Addendum 2

MA24- 5041 Judith Nyman Secondary School Exterior Wall and Soffit Repairs

Project	Judith Nyman PS – Exterior Wall and Soffit Repairs	Addendum No.	2
Project No.	23-0487-00	Date	May 10, 2024
Re	Scope of Work Clarifications	Pages	1 of 3
From	Engineering Link Incorporated

1 NORTH ELEVATION
SCALE: N.T.S.

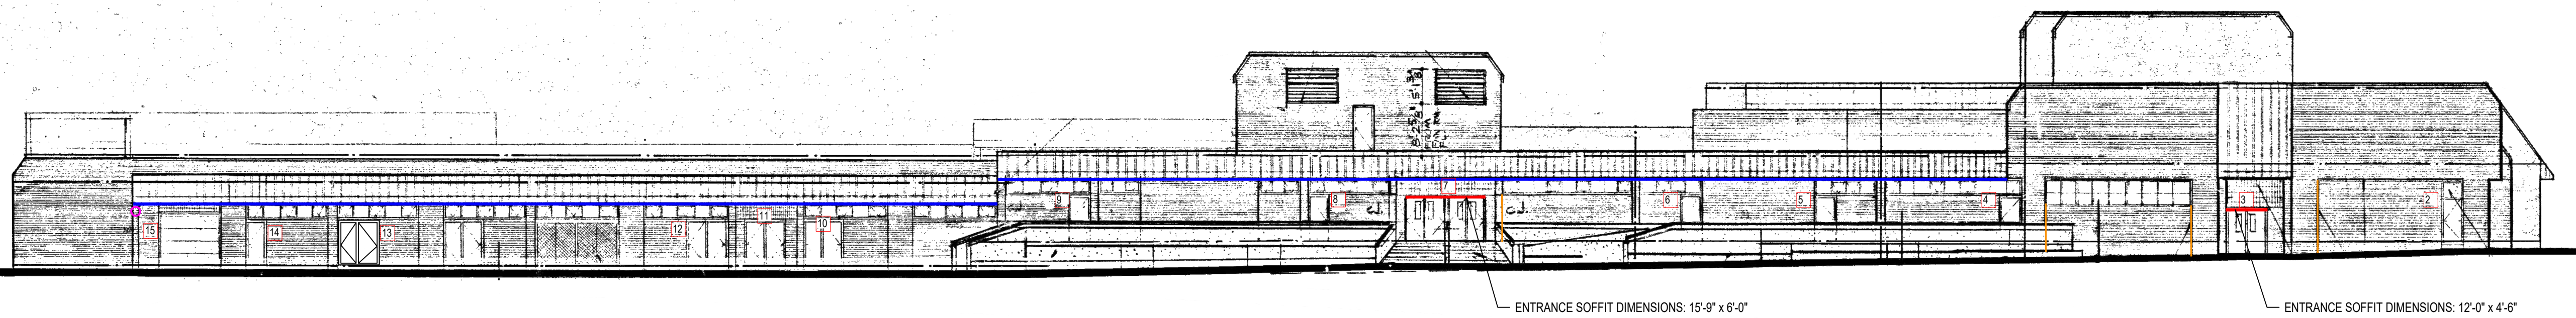
Question 1: Please advise soffit width and length of high soffits on North elevation.

Question 2: Please advise soffit width and length of entrance soffit on North elevation.

Answer 1: Refer to revised drawing provided.

Answer 2: Refer to revised drawing provided.

SOFFIT REPLACEMENT: LENGTH = 350'-0", WIDTH = 2'-6"

1 WEST ELEVATION
SCALE: N.T.S.

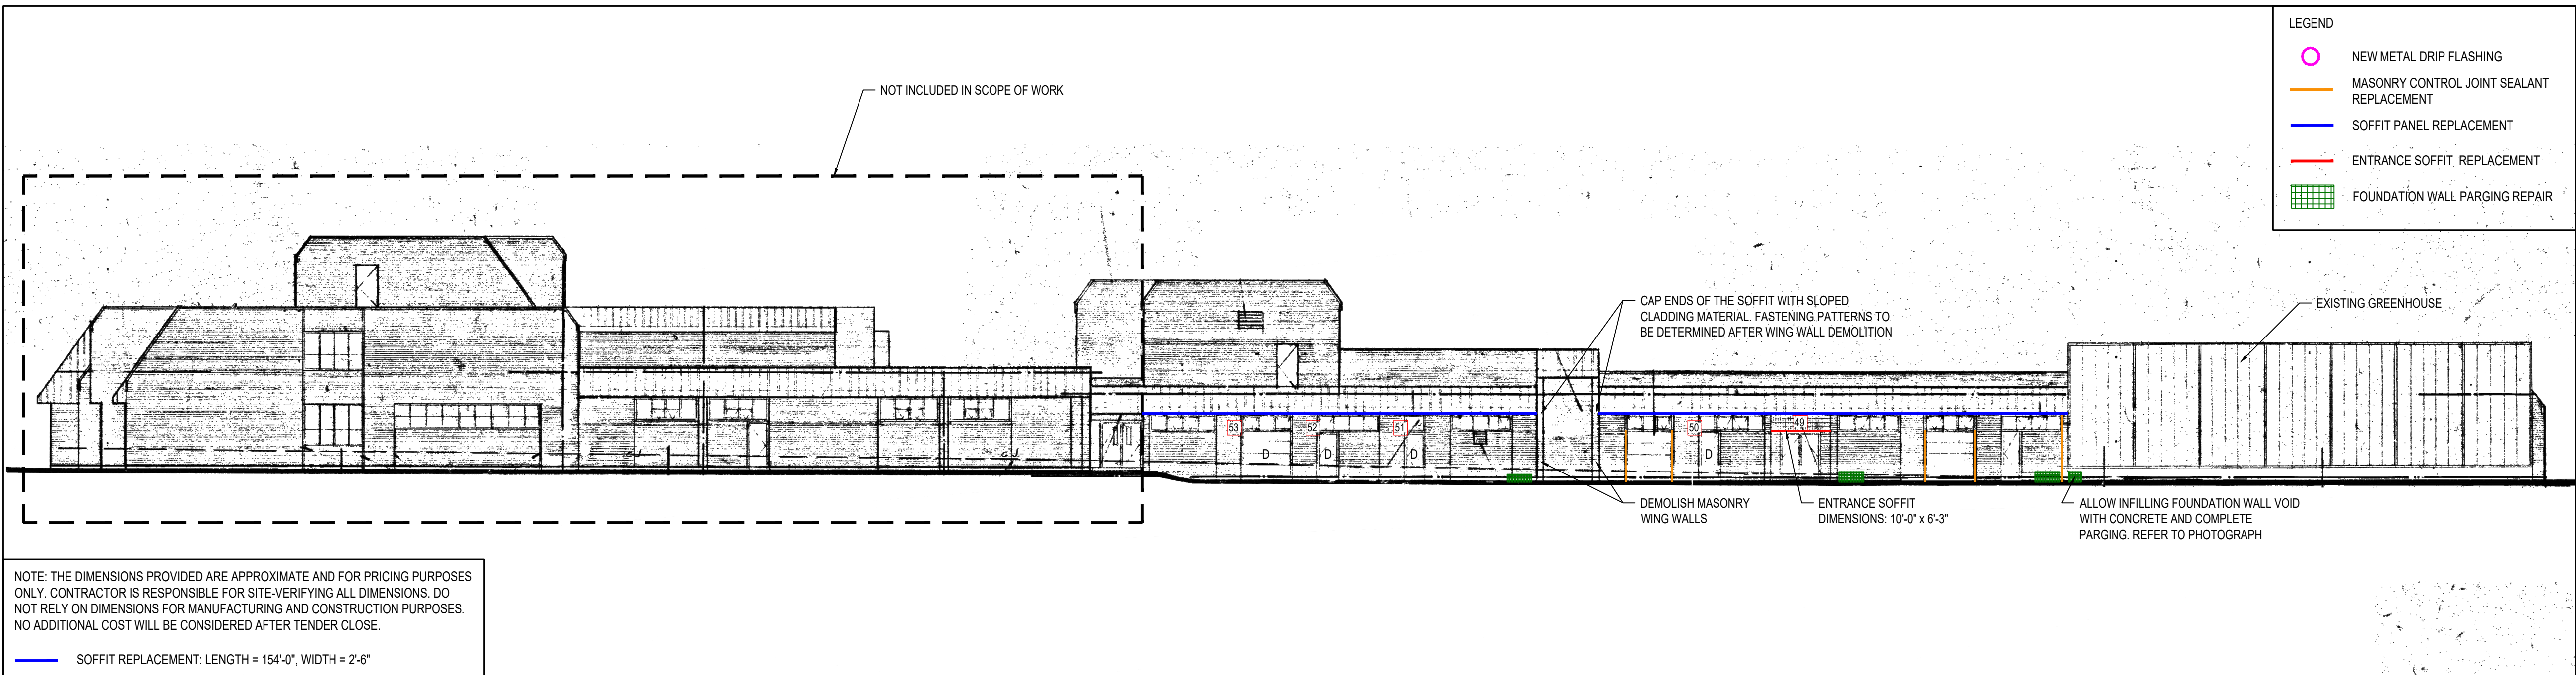
Question 7: Please advise soffit width and length of soffits on West elevation.

Answer 7: Refer to revised drawing provided.

2 SOUTH ELEVATION
SCALE: N.T.S.

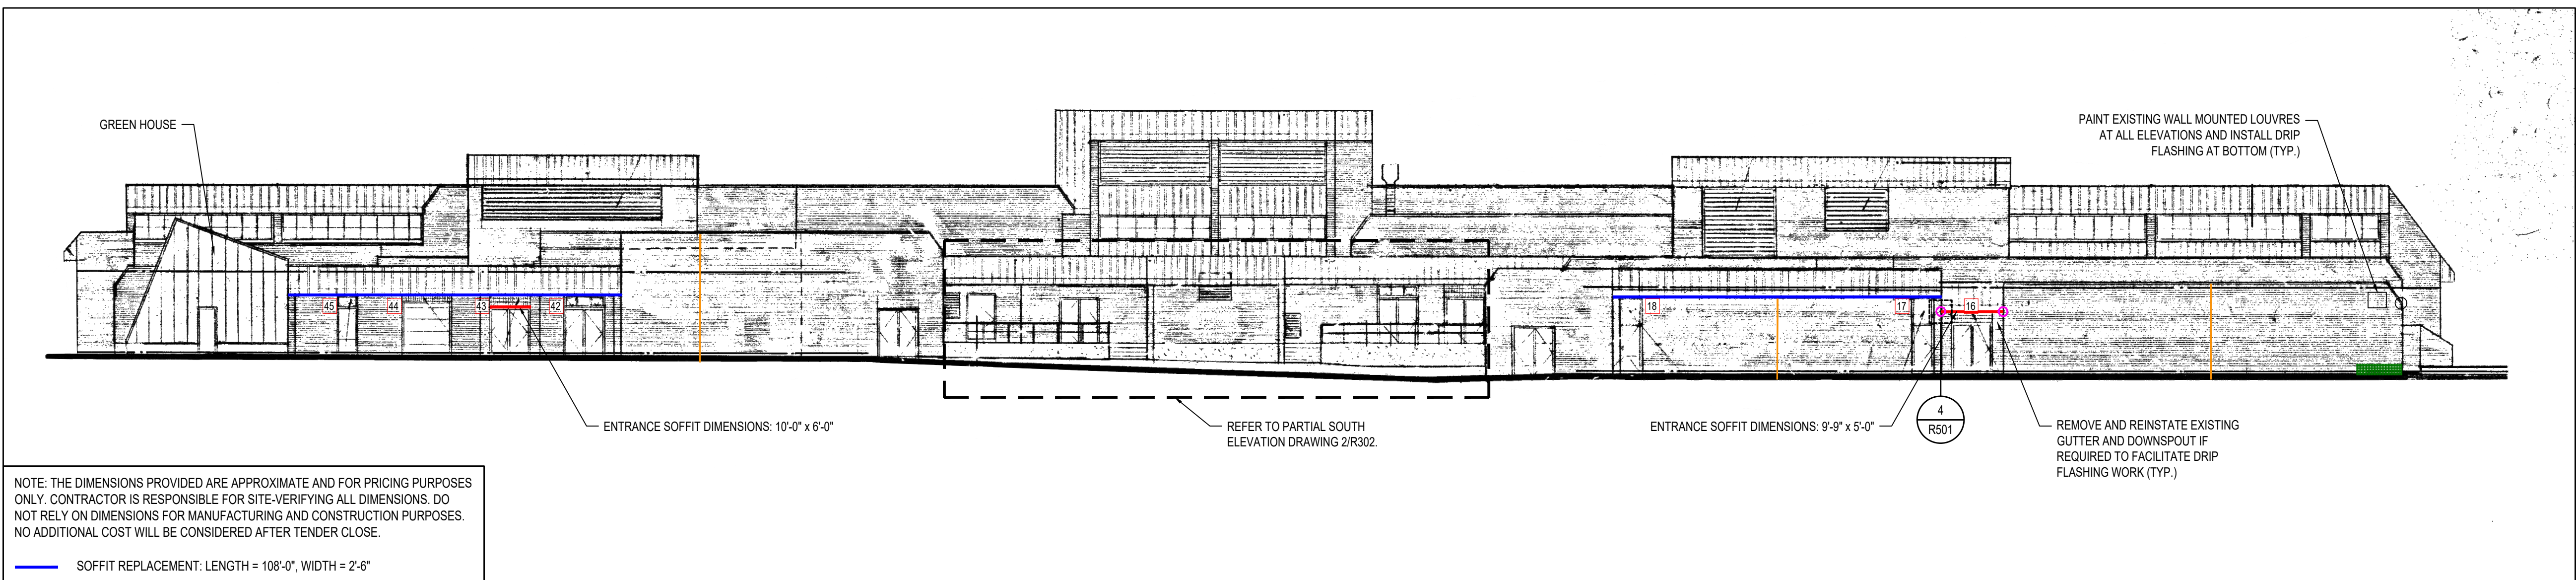
Question 8: Please advise soffit width and length of soffits on South elevation.

Question 9: Please advise soffit width and length of entrance soffit on South elevation.

Answer 8: Refer to revised drawing provided.

Answer 9: Refer to revised drawing provided.

1 PARTIAL EAST ELEVATION
SCALE: NTS

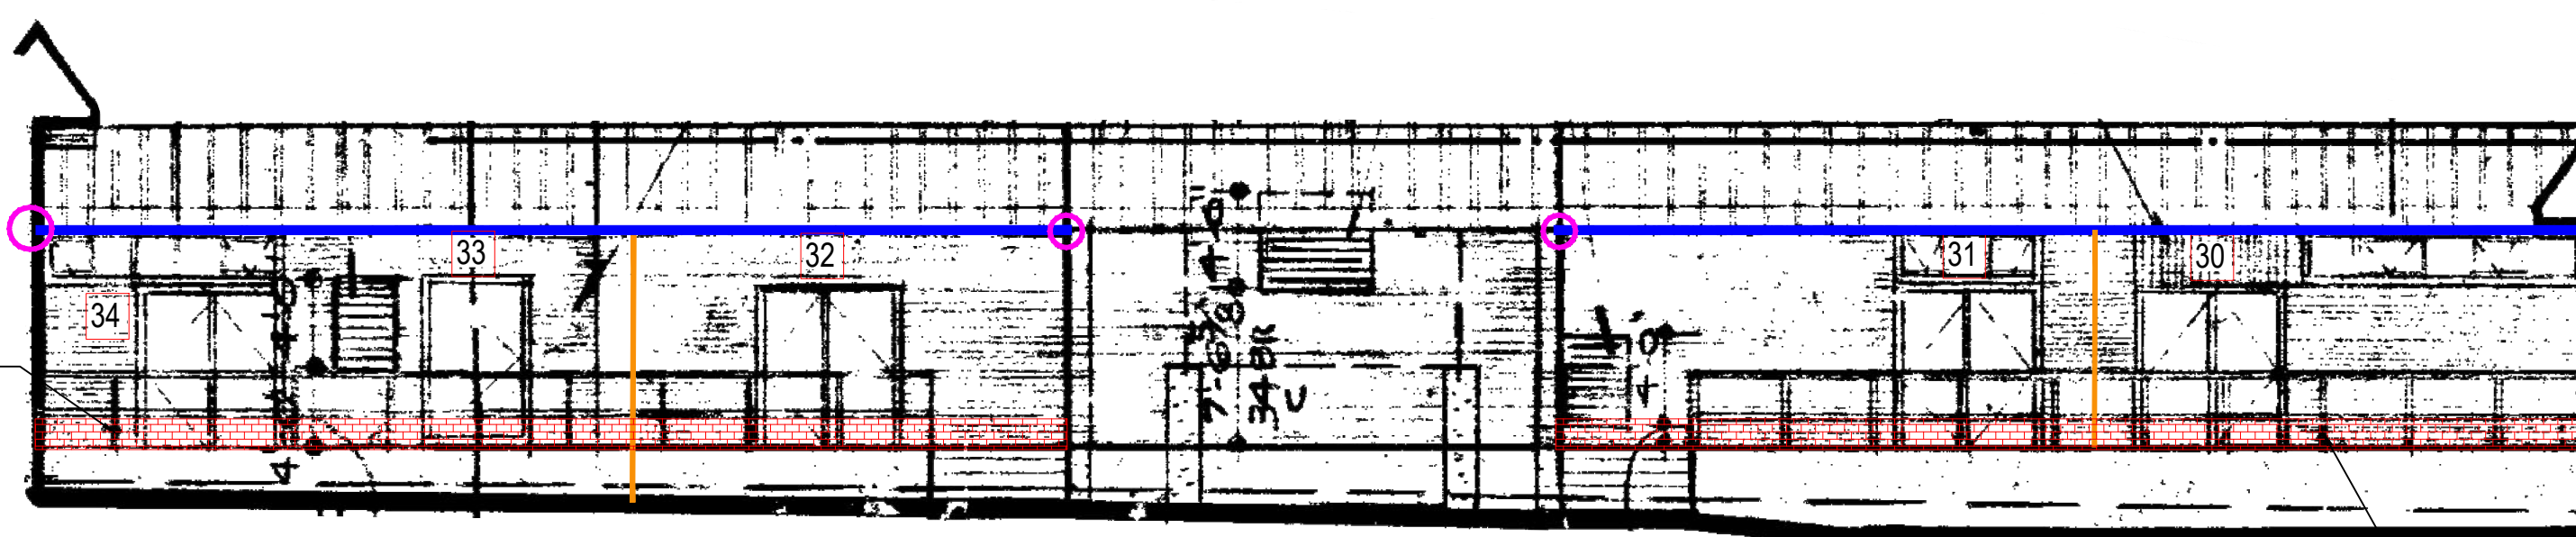
Question 10: Please advise soffit width and length of lower soffit on partial East and West elevation.

Question 11: Please advise soffit width and length of higher soffit on partial East and West elevation.

Answer 10: Refer to revised drawing provided.

Answer 11: Refer to revised drawing provided.

SOFFIT REPLACEMENT: LENGTH = 172'-0", WIDTH = 2'-6"

2 PARTIAL SOUTH ELEVATION
SCALE: NTS

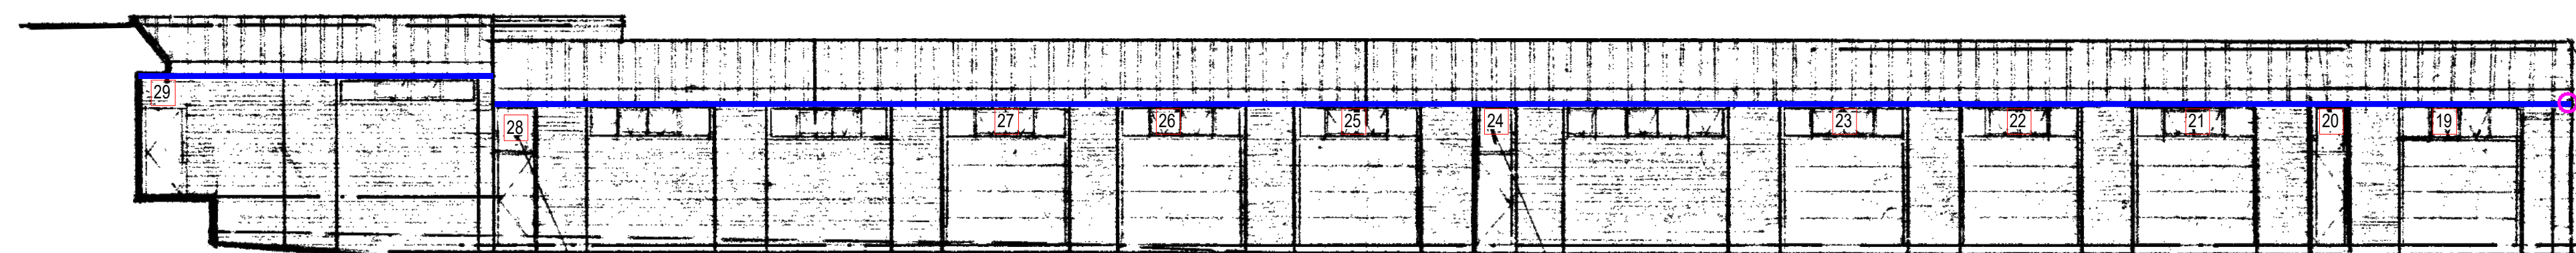
Question 12: Please advise soffit width and length of soffits on partial South elevation.

Answer 12: Refer to revised drawing provided.

SOFFIT REPLACEMENT: LENGTH = 112'-0", WIDTH = 2'-6"

2 NEW SOFFIT DETAIL
SCALE: N.T.S.

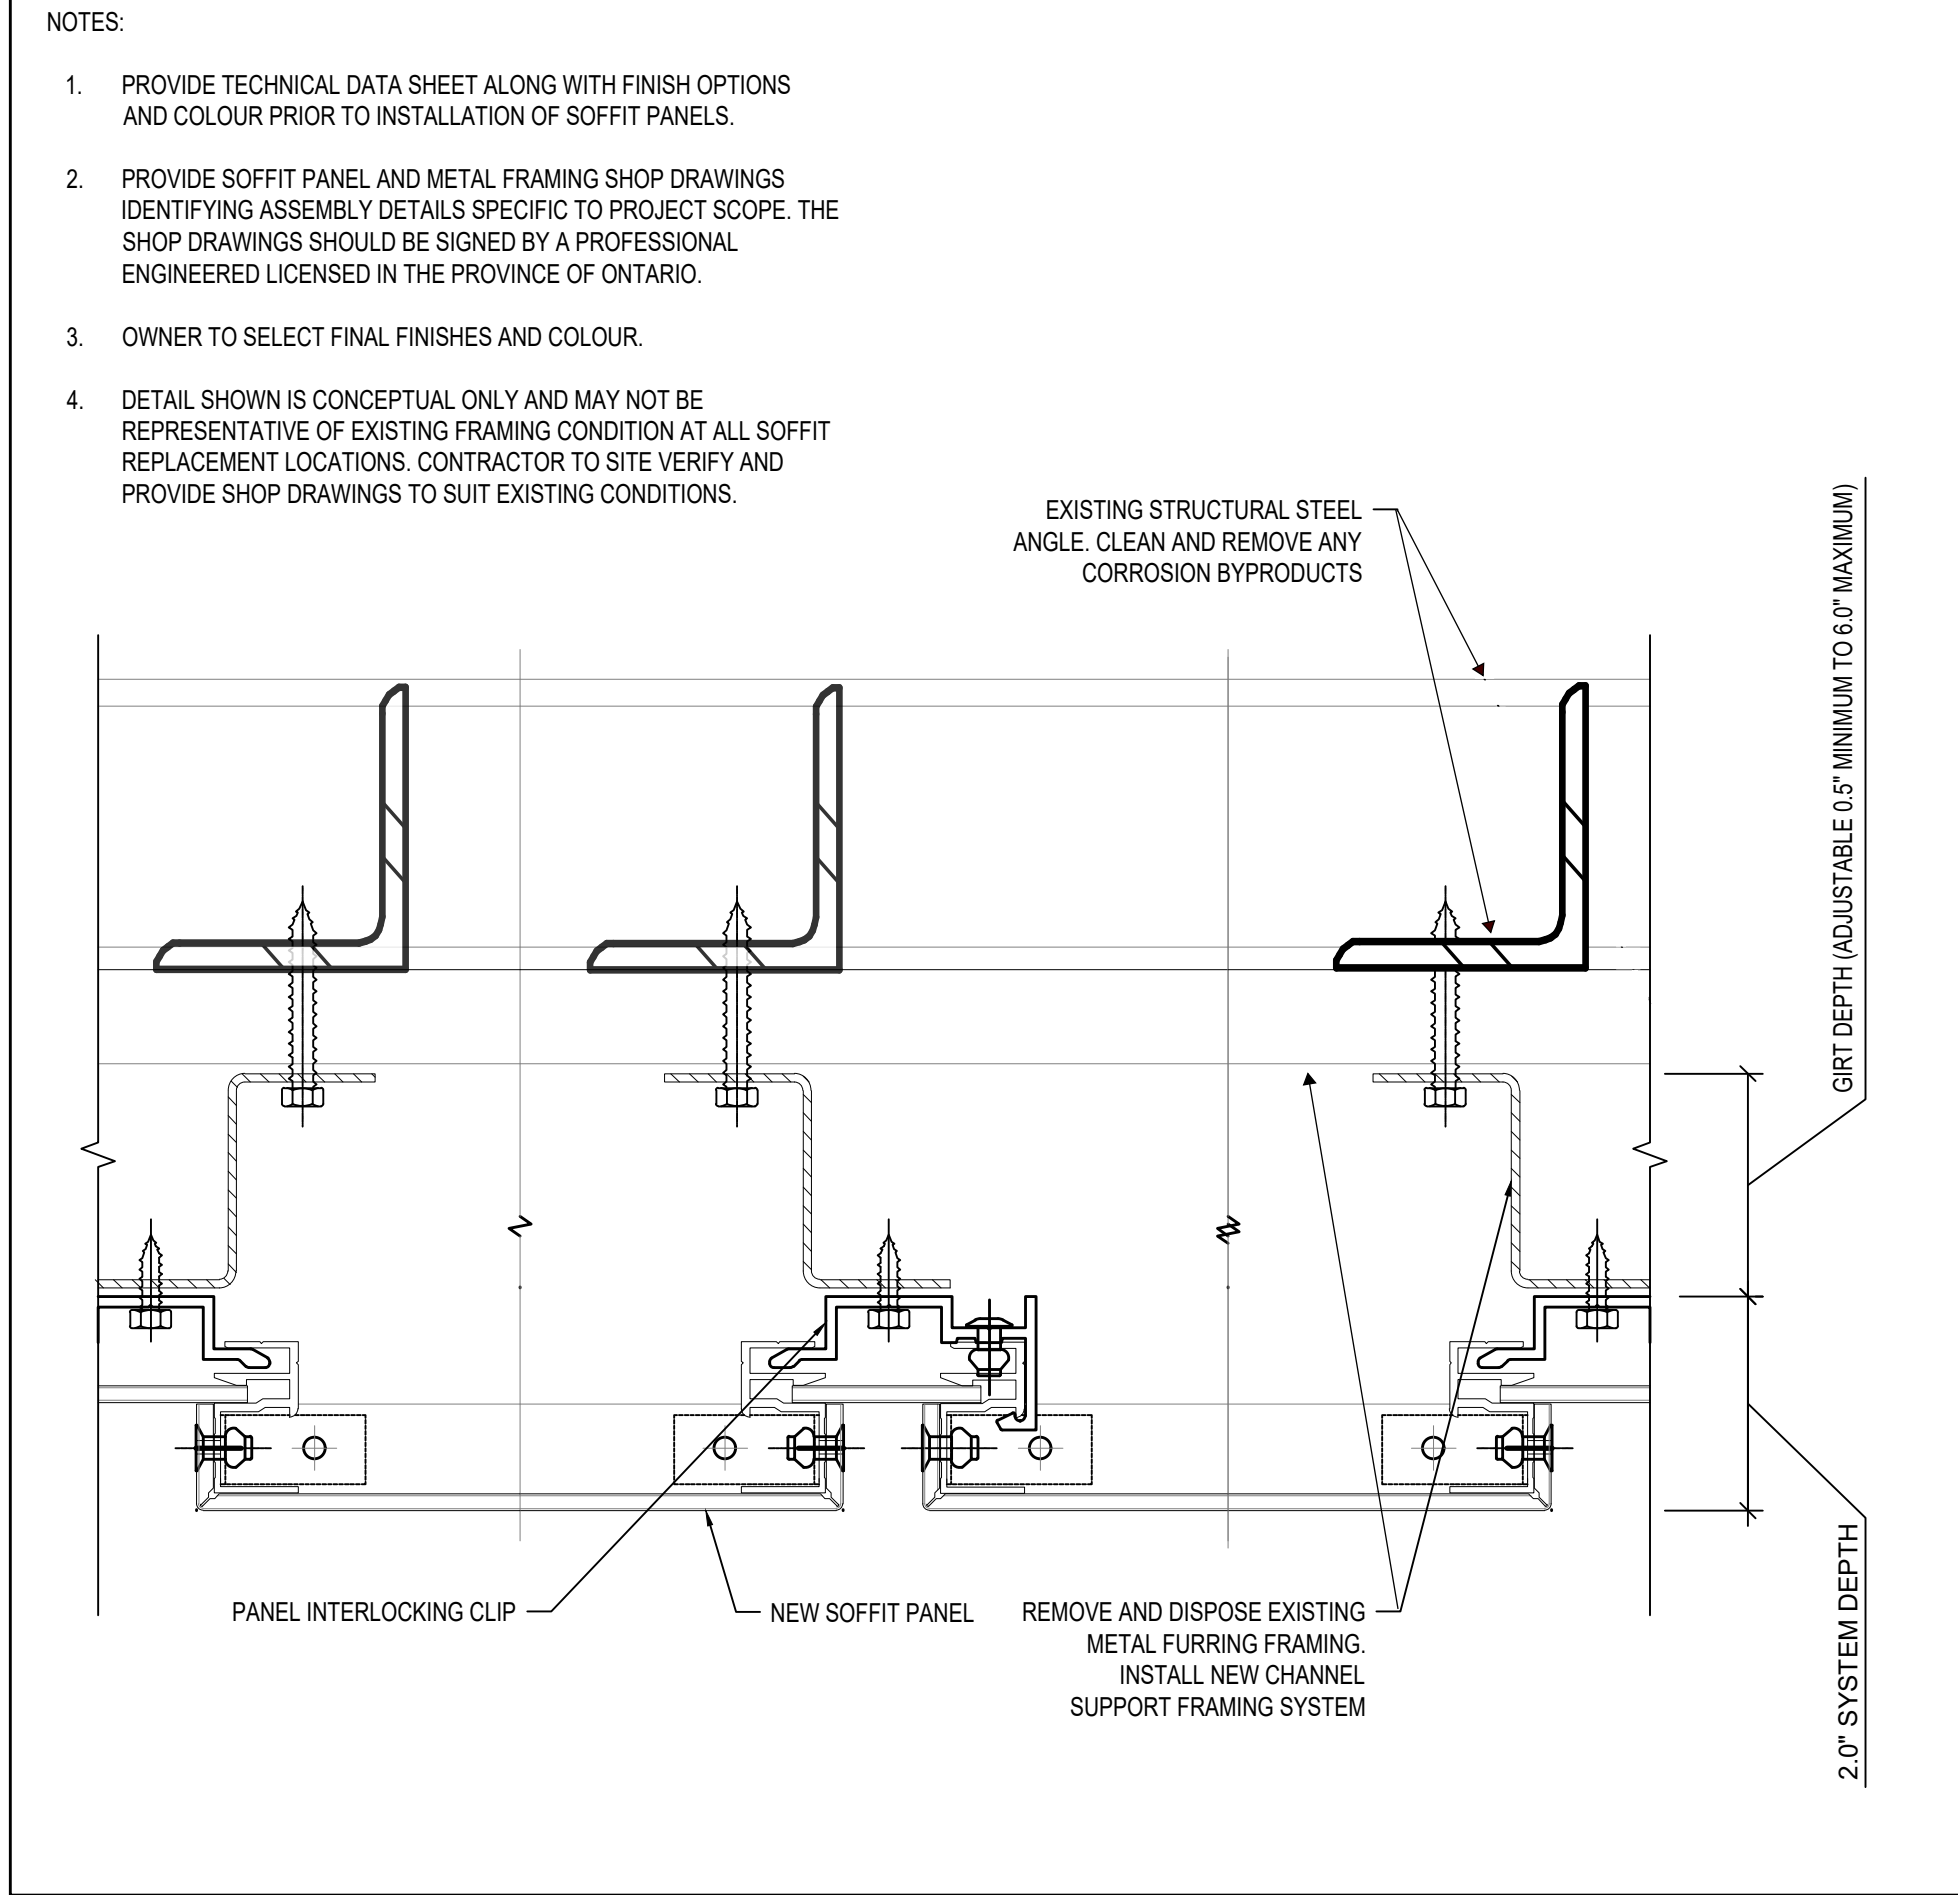
Question 15: Should we apply this panel layout on all soffits - 6" wide panels with 3/4" reveals or can we propose a different joint layout with less panels and better material optimization and lower cost?

Answer 15: The panel layout is to be determined by the system design Engineer and shown on the shop drawings.
